**CONSTRUCTION BULLETIN
No. 002**

**Institution: California Institution for Men (CIM)
Project Name: Replace Roofs Phase 1
Construction Bulletin Number: 002
Date of Issuance: February 6, 2026**

Description: This Bulletin makes modifications and corrections to the Project Manual and Drawings as described below.

T0.1

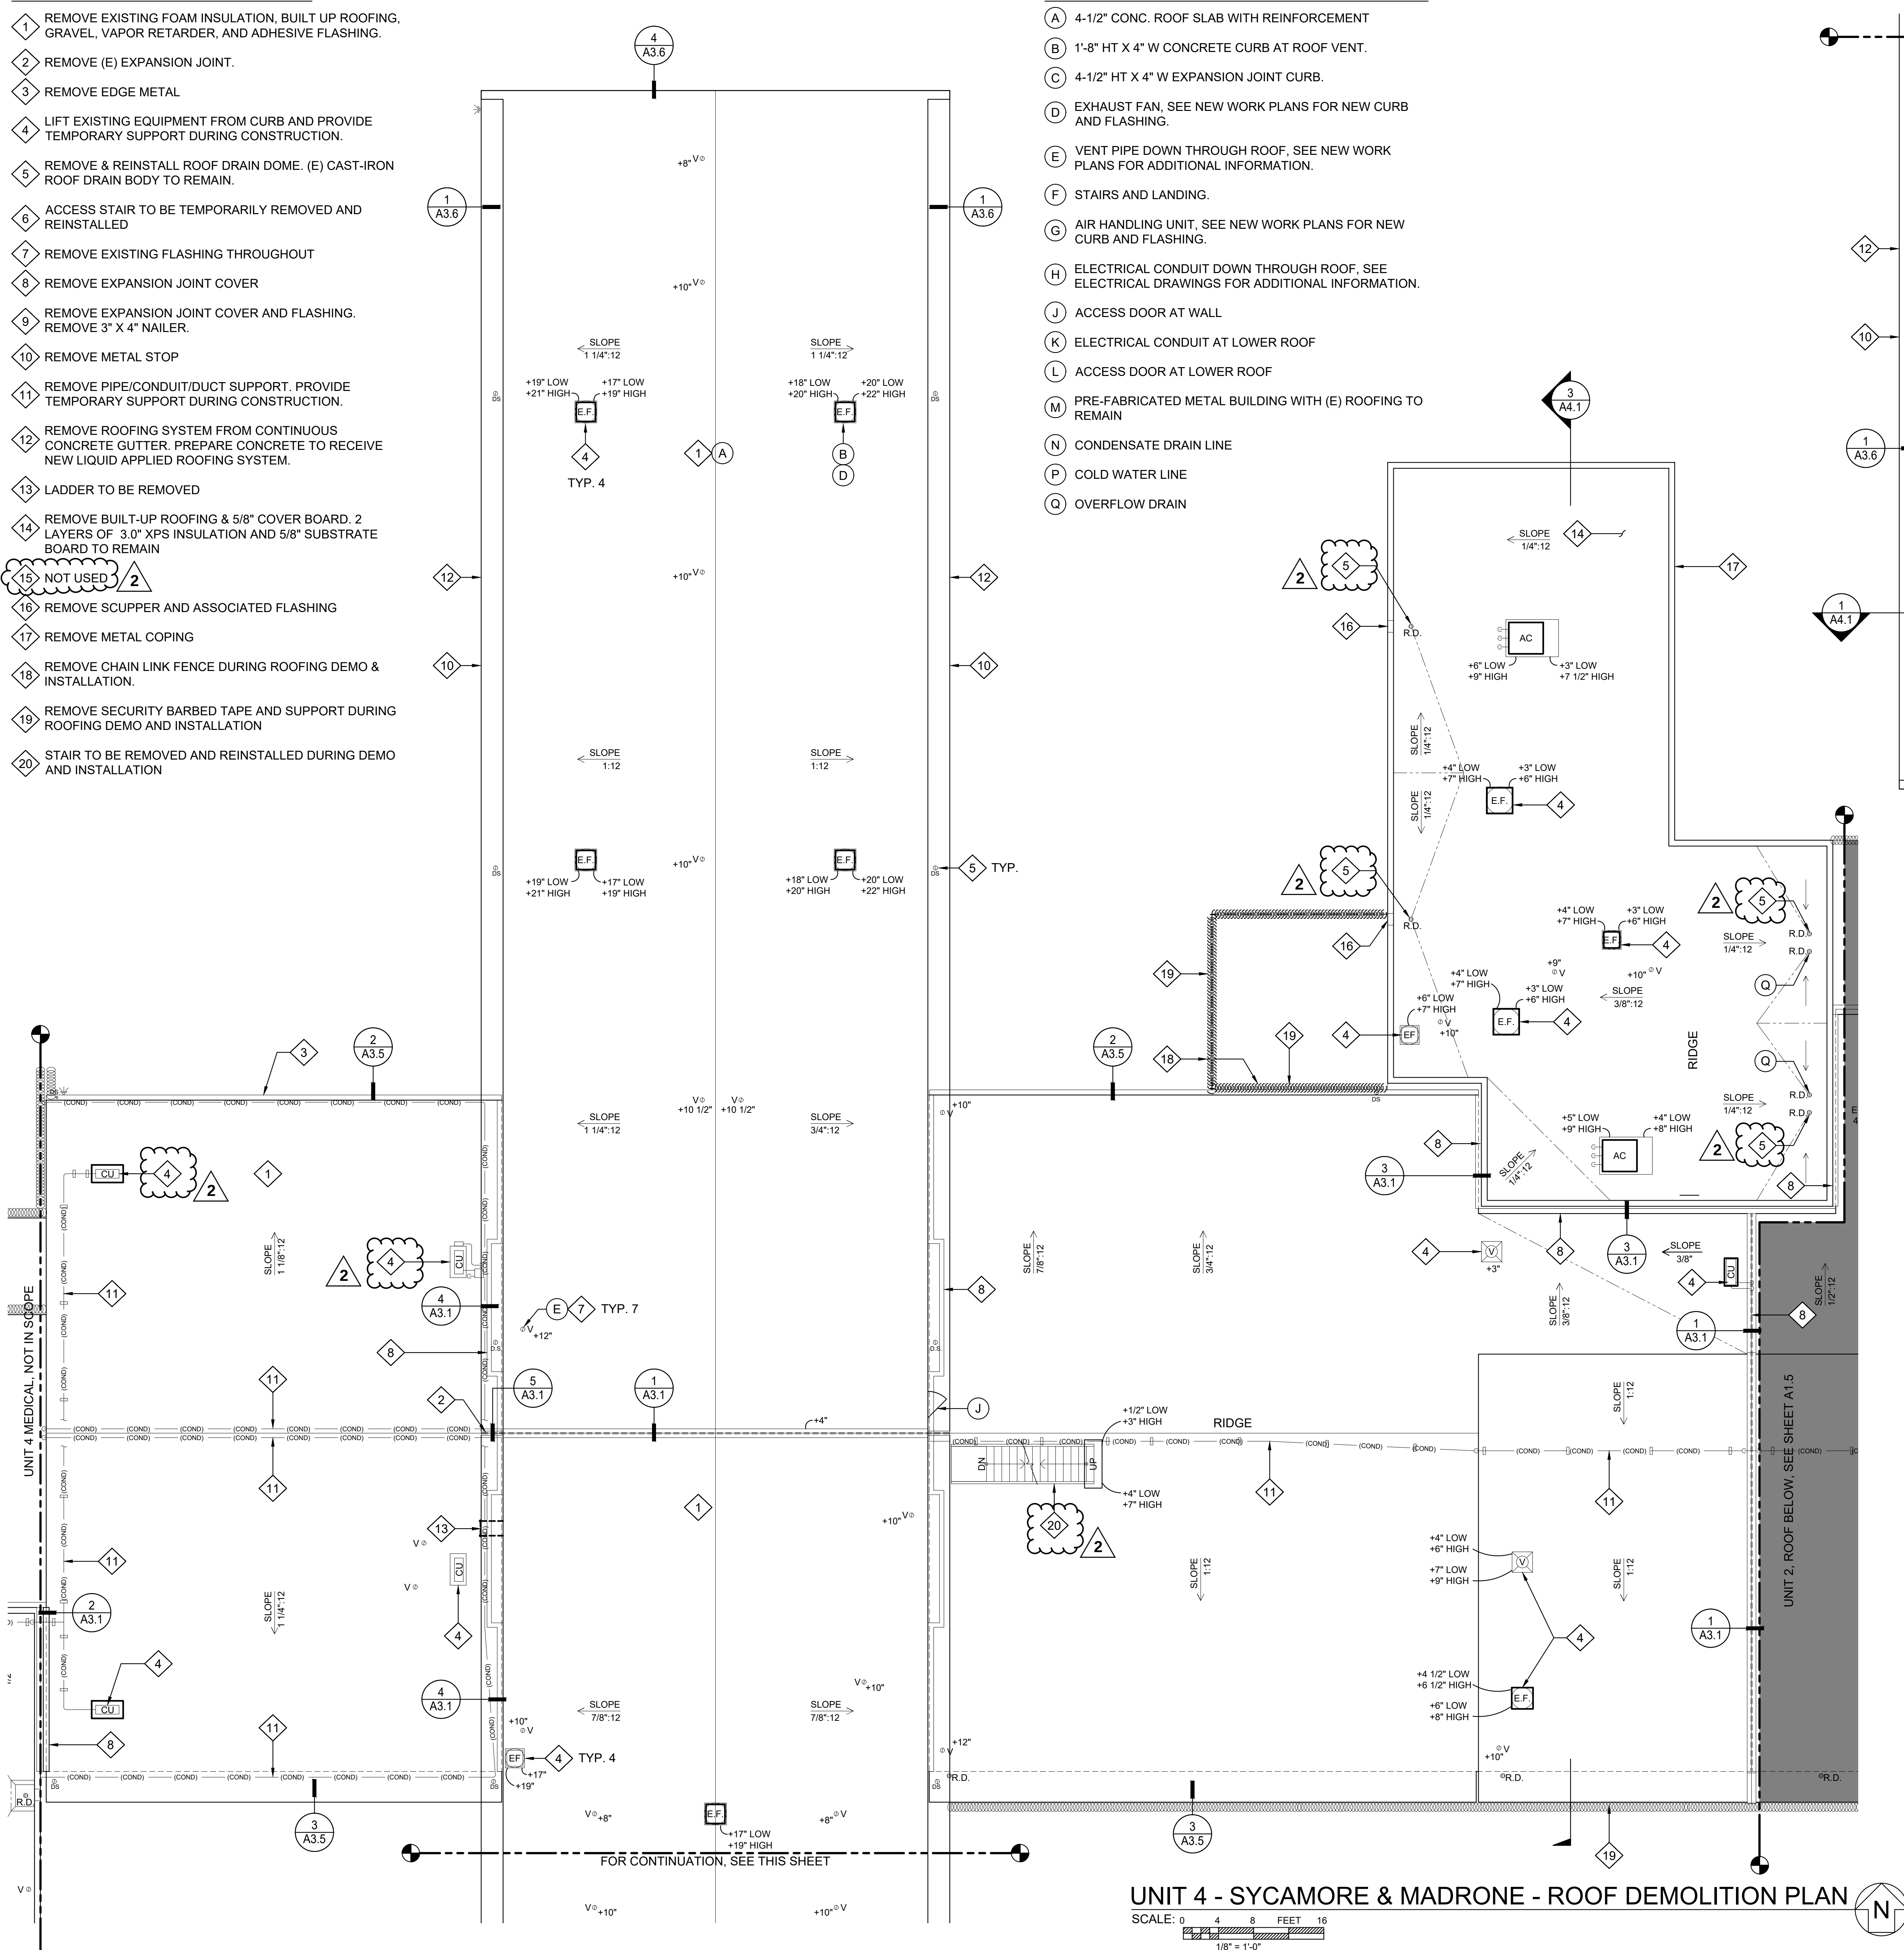
2. Sheet **T0.1 – TITLE SHEET:**
 - a. **Add** OSFM Permit Number:
 - b. **Add** two new sheets to SHEET INDEX; Sheets A3.11 MECHANICAL PENTHOUSE DETAILS and A3.12 MECHANICAL PENTHOUSE DETAILS

- c. **Modify** SHEET COUNT from 78 to 80 SHEETS
3. Sheet **A1.1 – UNIT 4 – SYCAMORE & MADRONE – ROOF DEMOLITION PLAN**
 - a. **Modify** text of Demolition Keynote 15 from REMOVE ROOF DRAIN to NOT USED

DATE: 11/03/2025
SHEET NUMBER
A1.2
06 OF 80 SHEETS V1

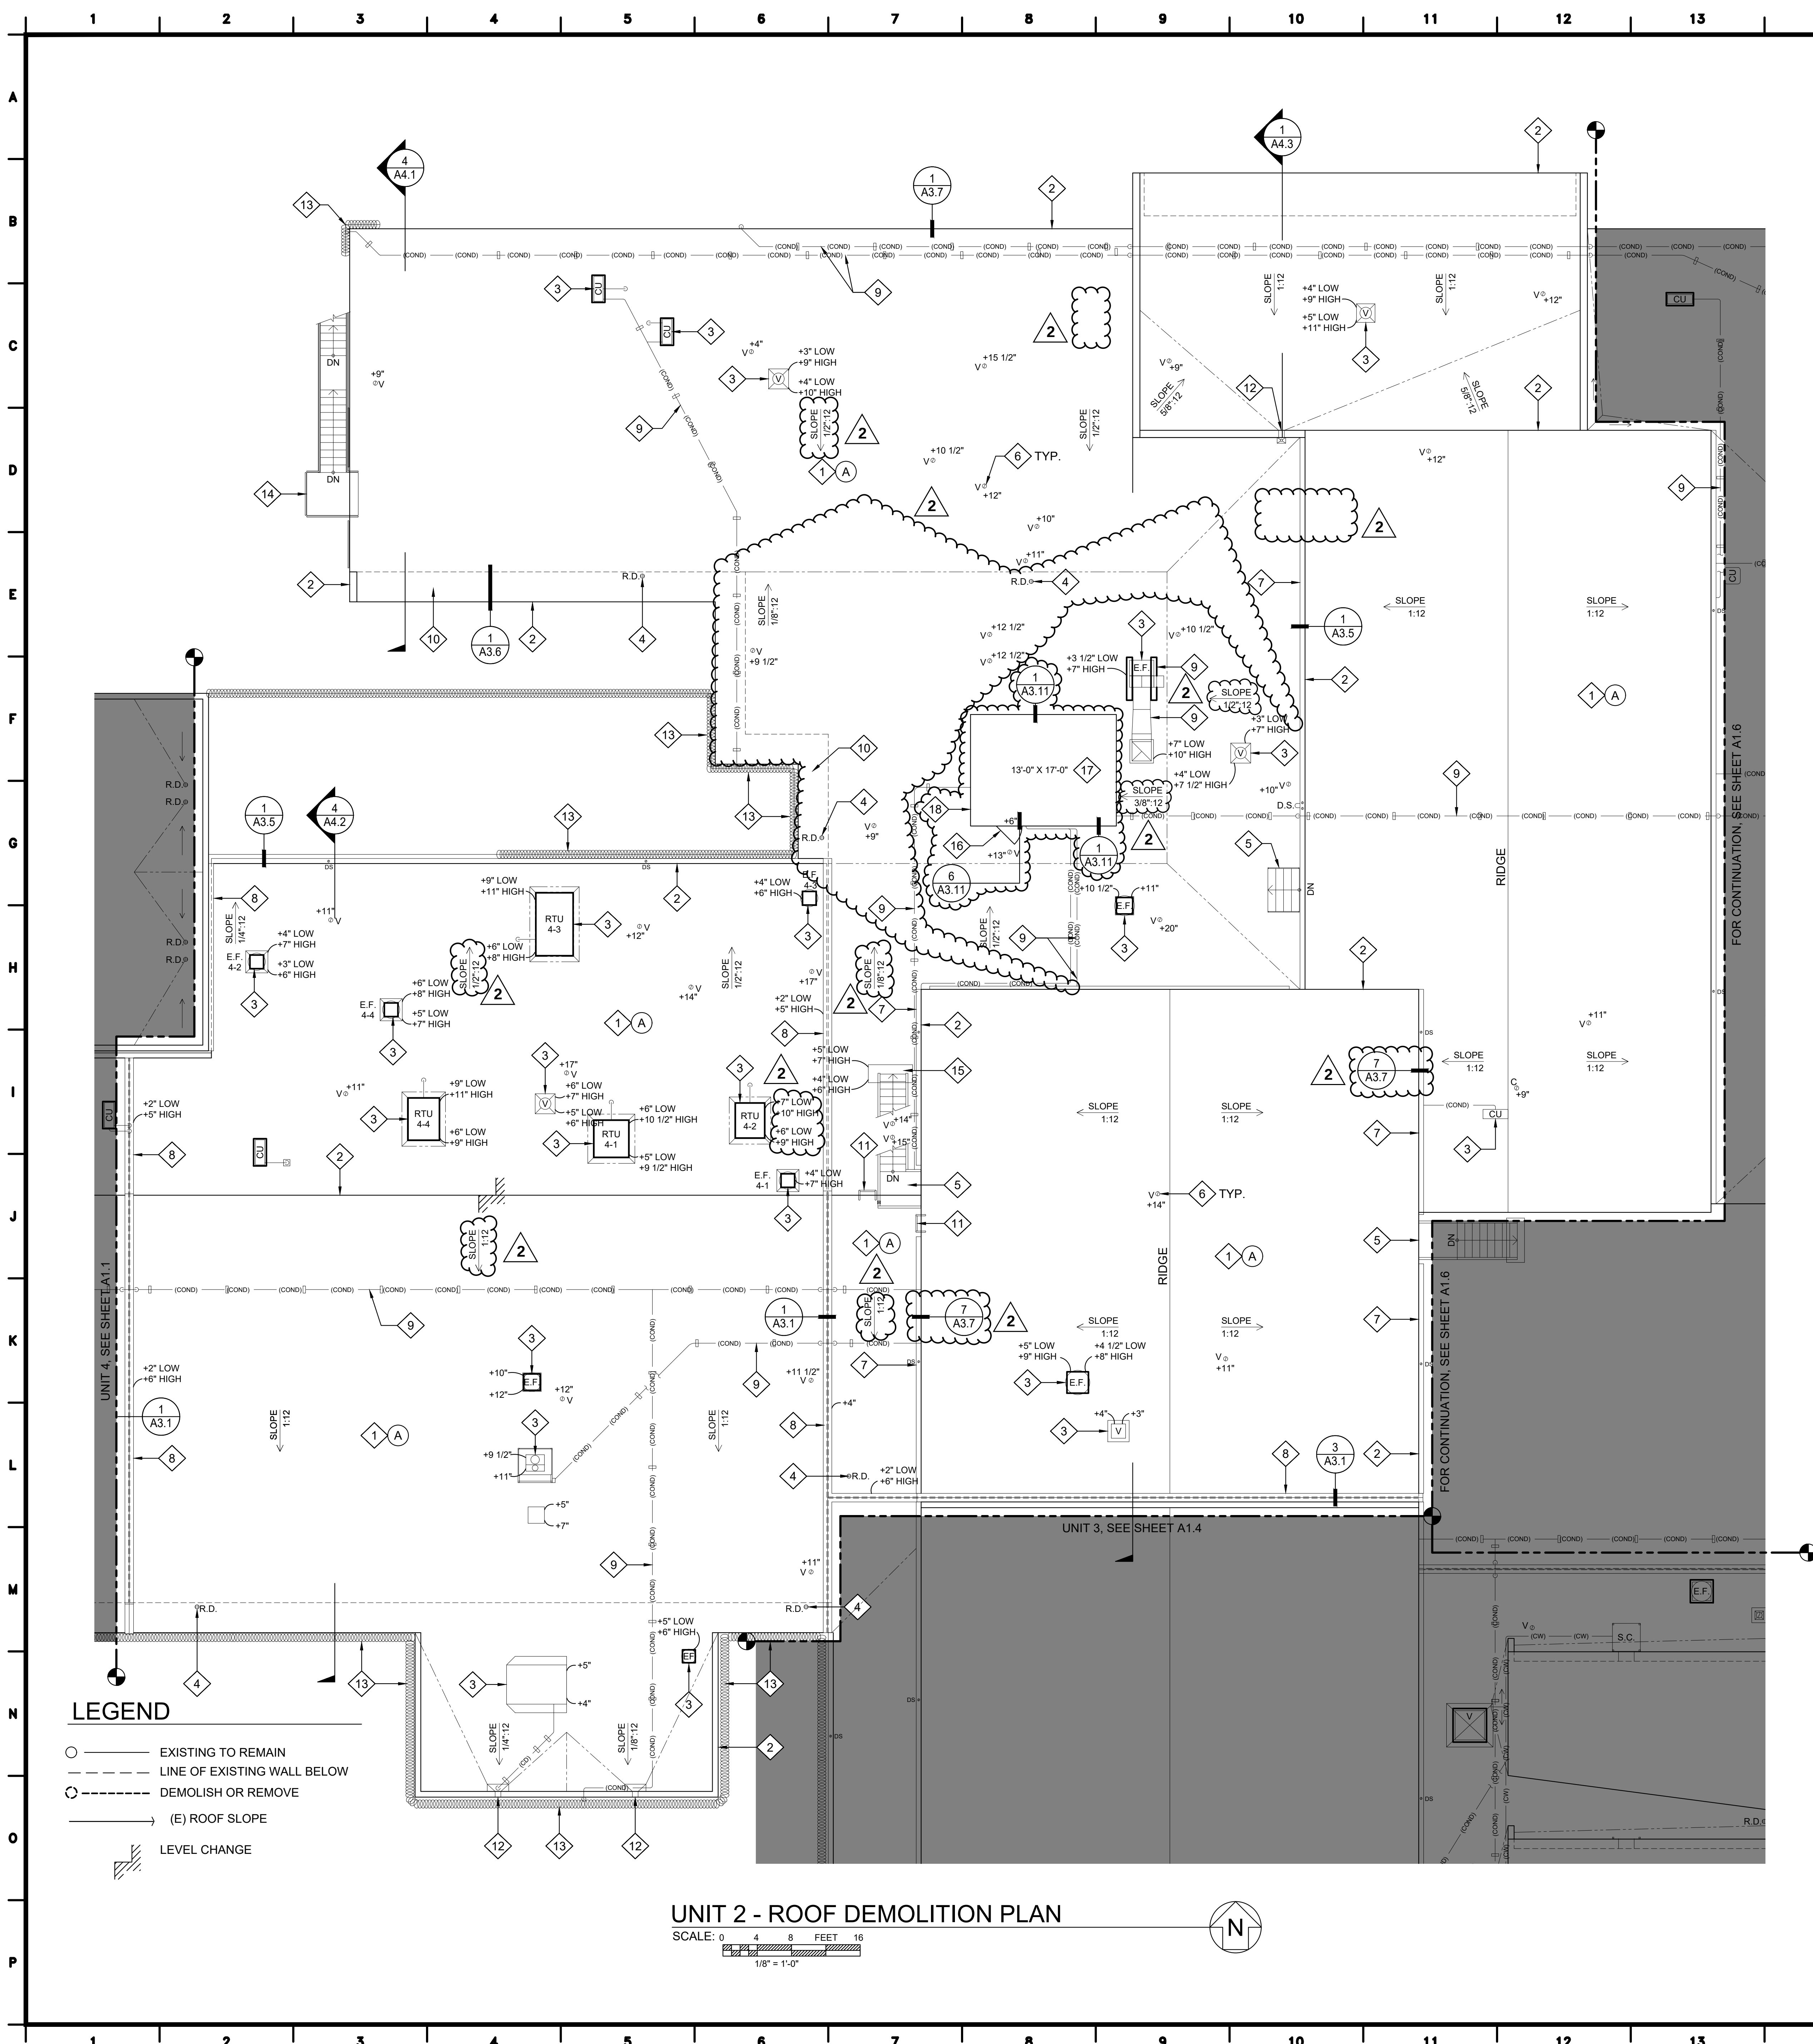
- h. **Change** DEMOLITION KEYNOTE tag number from 15 to 5
4. Sheet **A1.2 – UNIT 1 – CYPRESS & PALM – ROOF DEMOLITION PLAN**
 - a. **Change** DEMOLITION KEYNOTE tag number from 4 to 5
